Freeport-McMoRan Chino Mines Company
P.O. Box 10
Bayard, NM 88023

Re: Response to Request for Additional Information, Revision 24-2, 2024 CCP Update, Chino Mine, Permit No. GR009RE

Freeport-McMoRan Chino Mines Company (Chino) submitted an update to the Chino Closure- Closeout Plan on October 30, 2024. On October 28, 2025, Chino received comments from the New Mexico Mining and Mineral Division and other state agencies. This letter provides responses to these combined comments. Below are the agency comments in italics followed by Chino's responses.

**FIGURE 11
NMA PMLU**

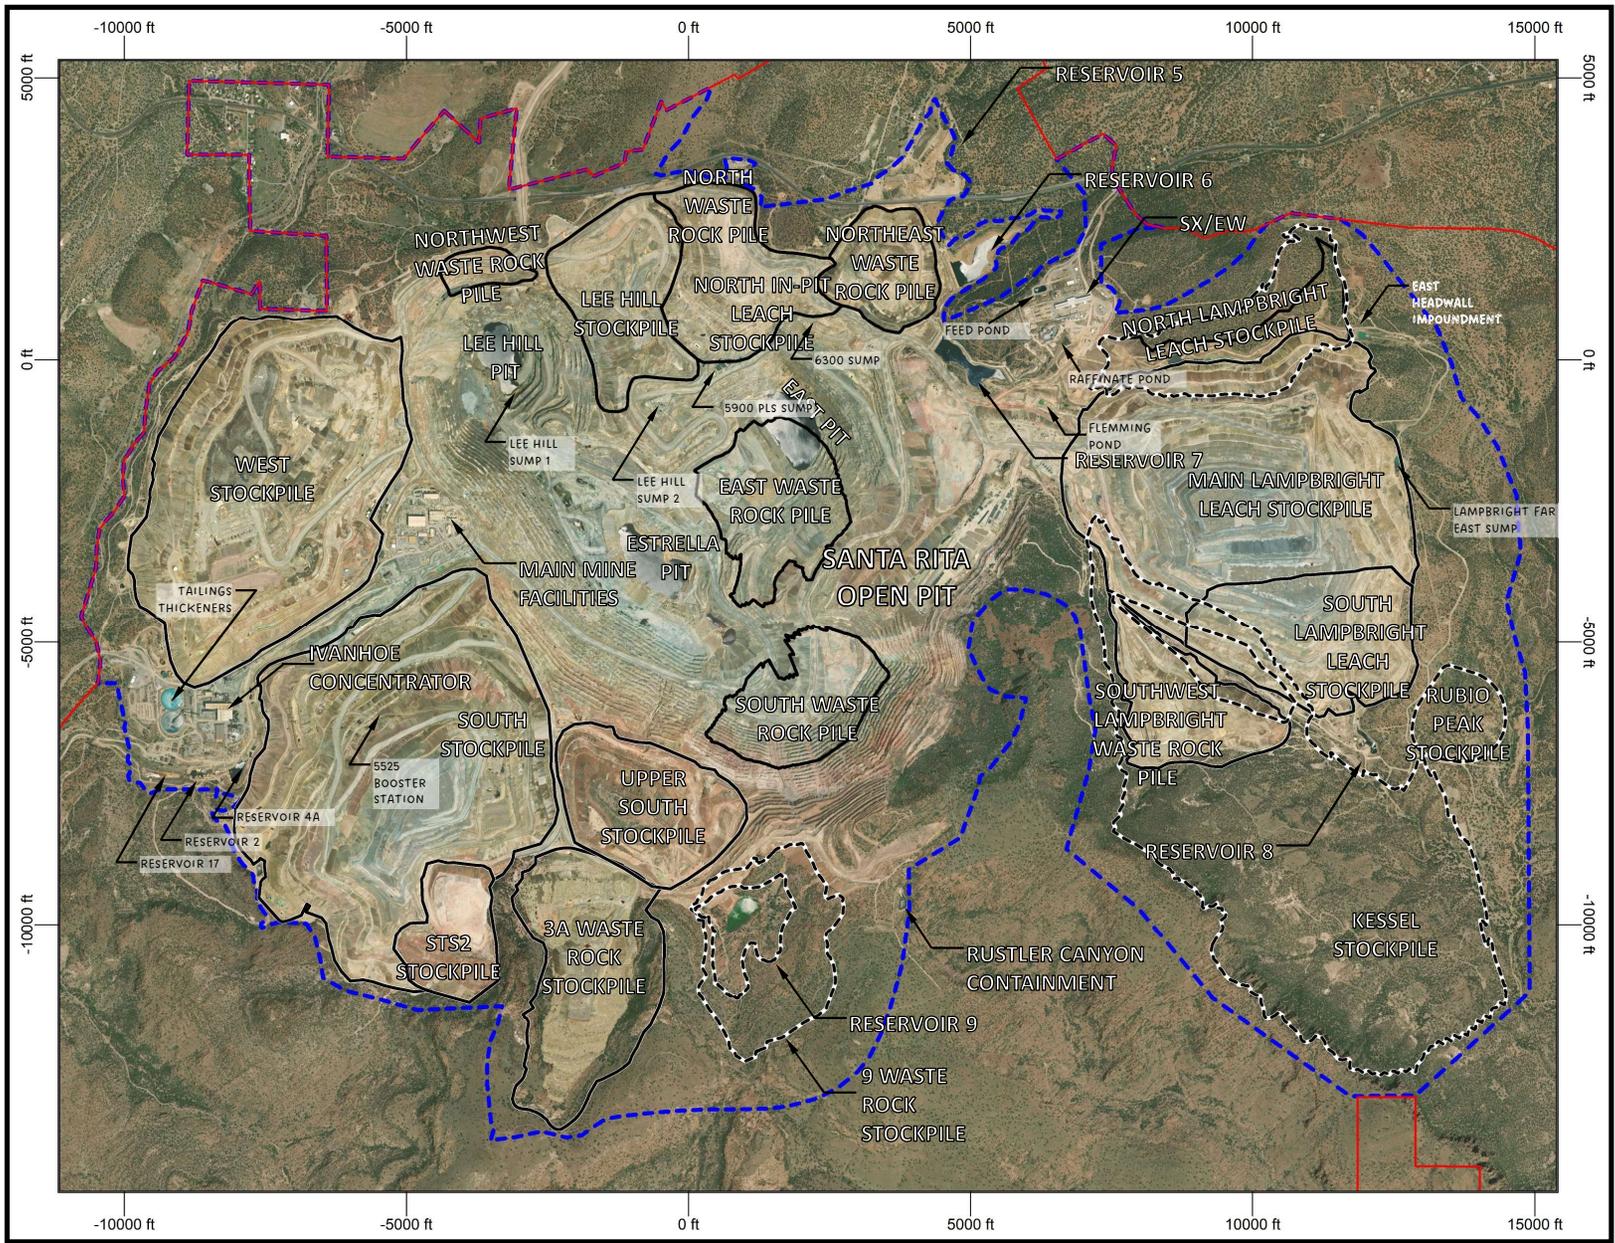
- The area on top of the West Stockpile dedicated to the salt/sludge storage is depicted inconsistently throughout the PAP, with varying extents described on Sheet 18, Figure 11, and Appendix G Figure 2. Please provide a new map detailing the extent of the West Stockpile that will be given the PMLU of Water Management compared to that which will be reclaimed as Wildlife Habitat or any other use.

Chino agrees that the Pit and Stockpile waivers should not be modified to include the Water Management PMLU. Figure 11 of the Main CCP and Sheet 9 of Appendix C were revised to remove the Water Management PMLU from within the pit and stockpile waiver areas.

Areas within conditional waiver areas approved in 2003 and within current open pit limit are removed. This is illustrated in the revised Figure 11 of the Main CCP.

Telesto calculated that the volume of salt generated could be stored within the area of the West Stockpile shown on Appendix G Figure 2; however, this may not be the best location considering surrounding reclamation, potential run-on issues and the need to avoid impacts to slopes and the Waiver area toward the Santa Rita Open Pit. Since the West Stockpile location generated the above final design-level questions, Chino proposes relocating the salt disposal facility for this conceptual design to the top surface of the North In-Pit Leach Stockpile and North Waste Rock Stockpile. A conceptual design of this facility is provided in revised Appendix C Sheet 11 and Figure 2 of Appendix G.

NMA POST-RECLAMATION TOPOGRAPHY

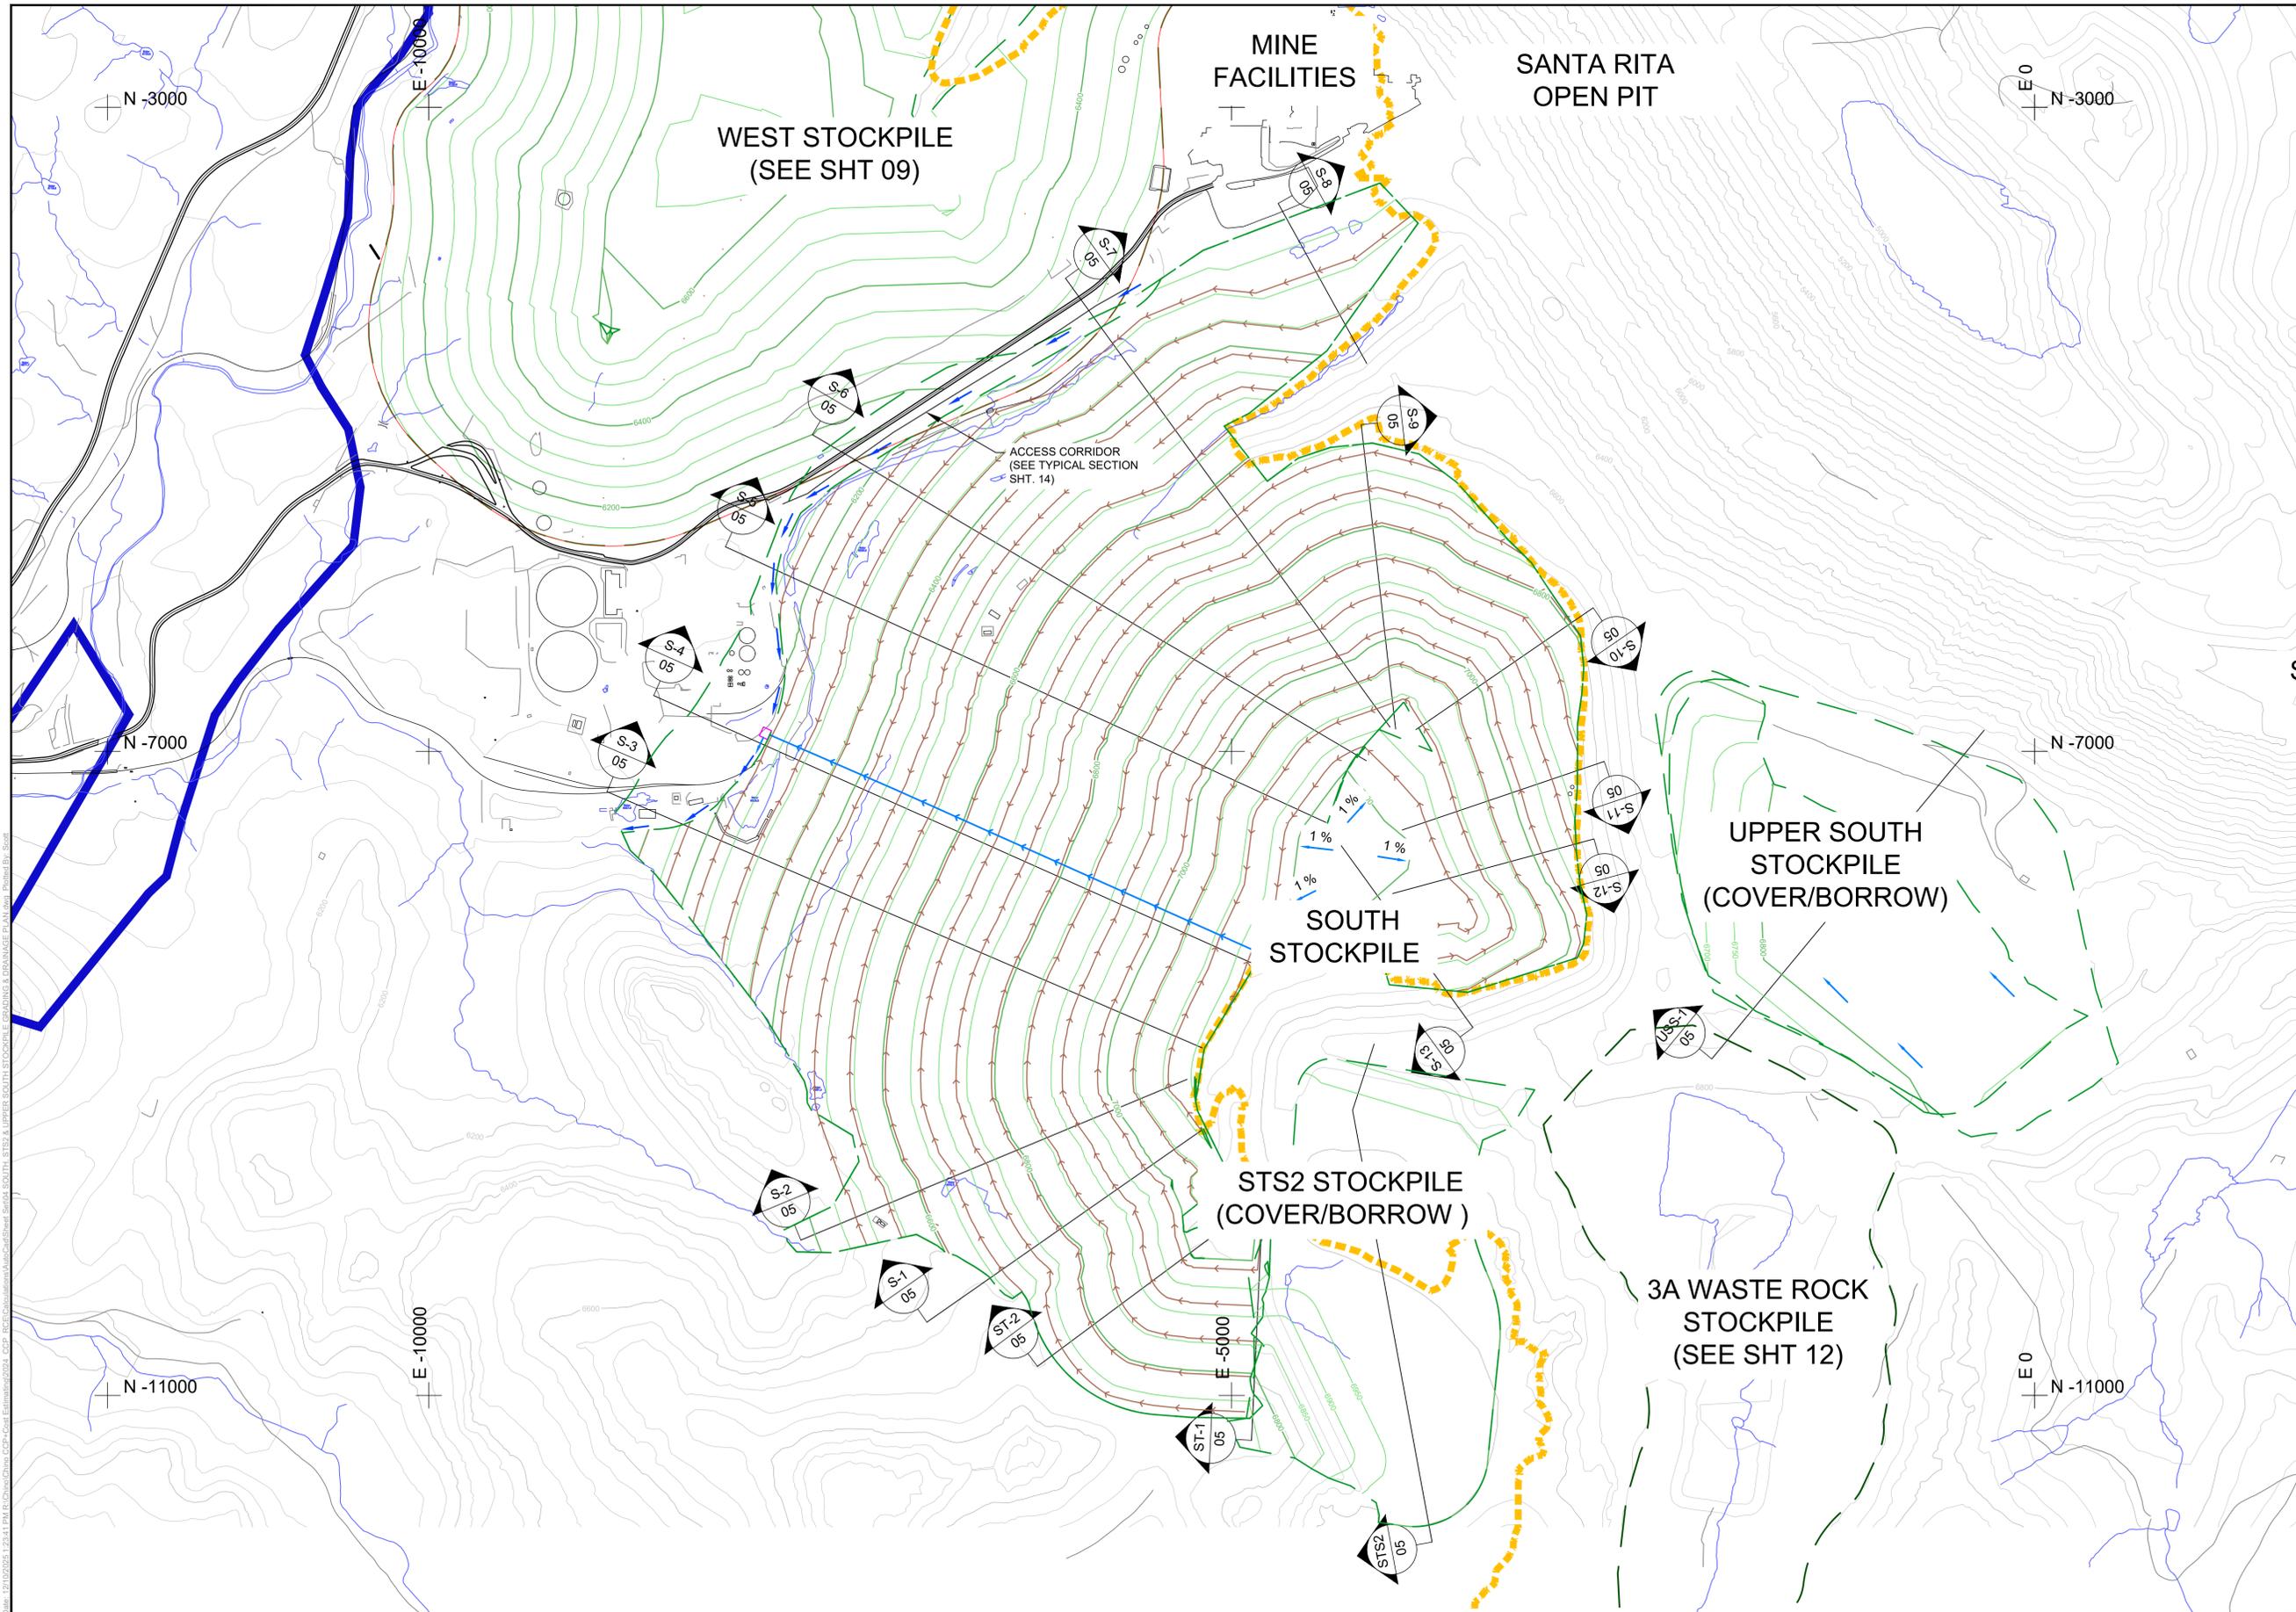
2. *Sheet 3 of Appendix C depicts the Northeast Stockpile within the Pit boundary area. MMD does not concur that the Northeast Stockpile is within the Pit Perimeter. Please revise the depiction of the Pit Perimeter in Sheet 3 and any other applicable figures in the Application or provide a justification for this determination.*

The current pit limit is corrected on the referenced drawing sheet and other pertinent figures (see attached drawings and figures).

WEST STOCKPILE GRADING & DRAINAGE PLAN

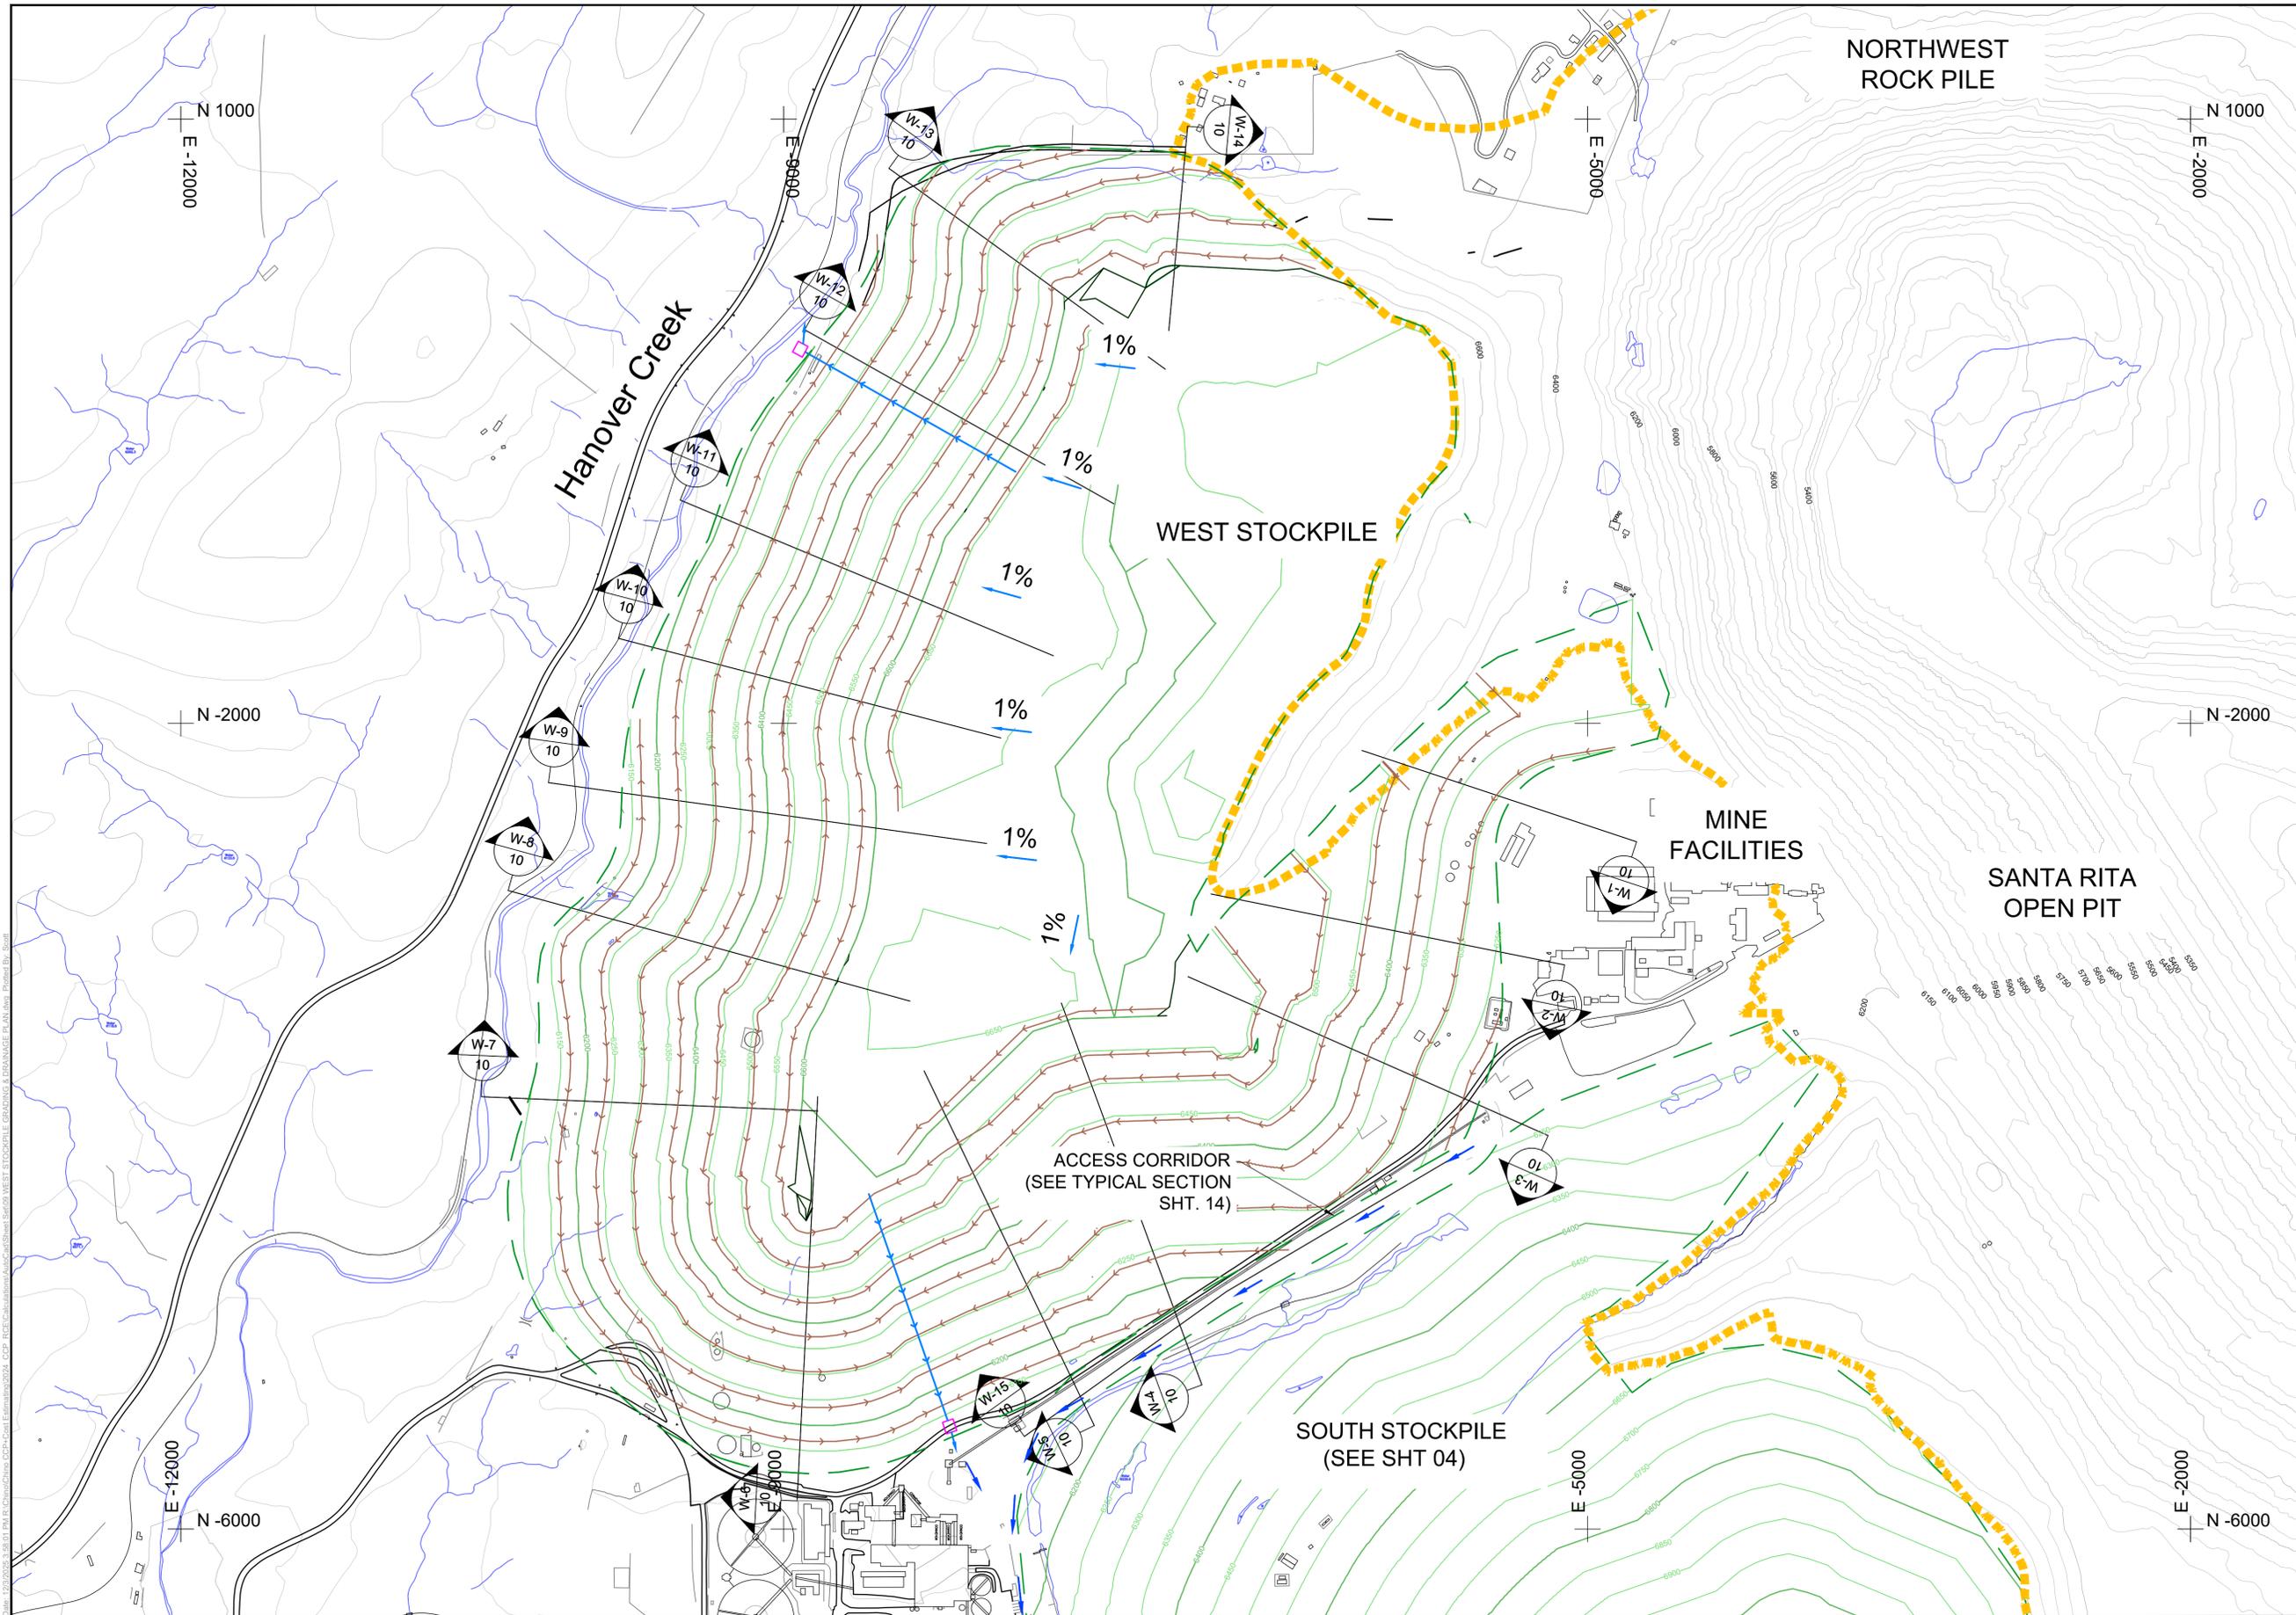
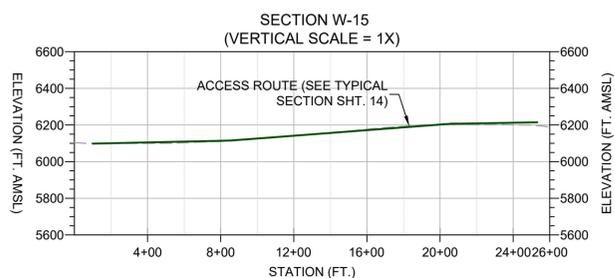
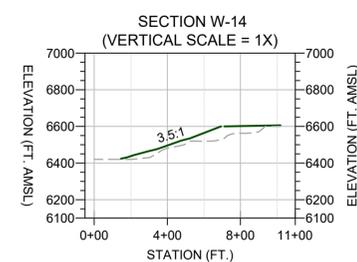
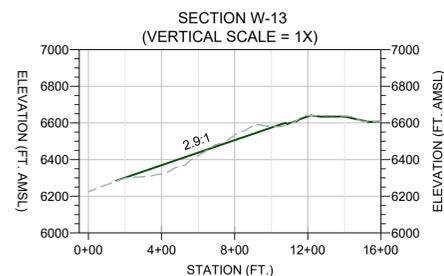
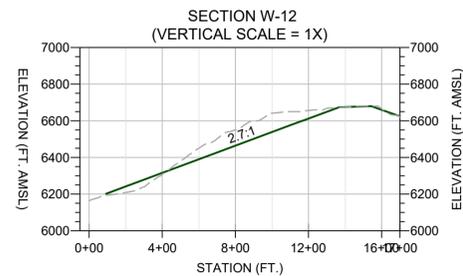
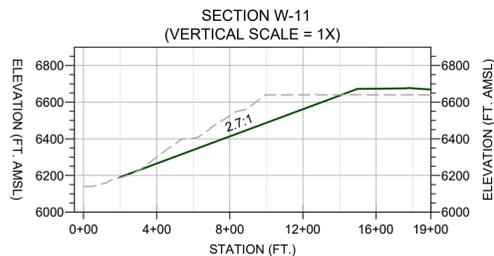
- Please clarify how the top of the West Stockpile will be graded, how cover will be placed, and how drainage pathways will be designed keeping in mind that transport of stored salt and sludge to either the Santa Rita Pit or the other outcrops should be minimized.
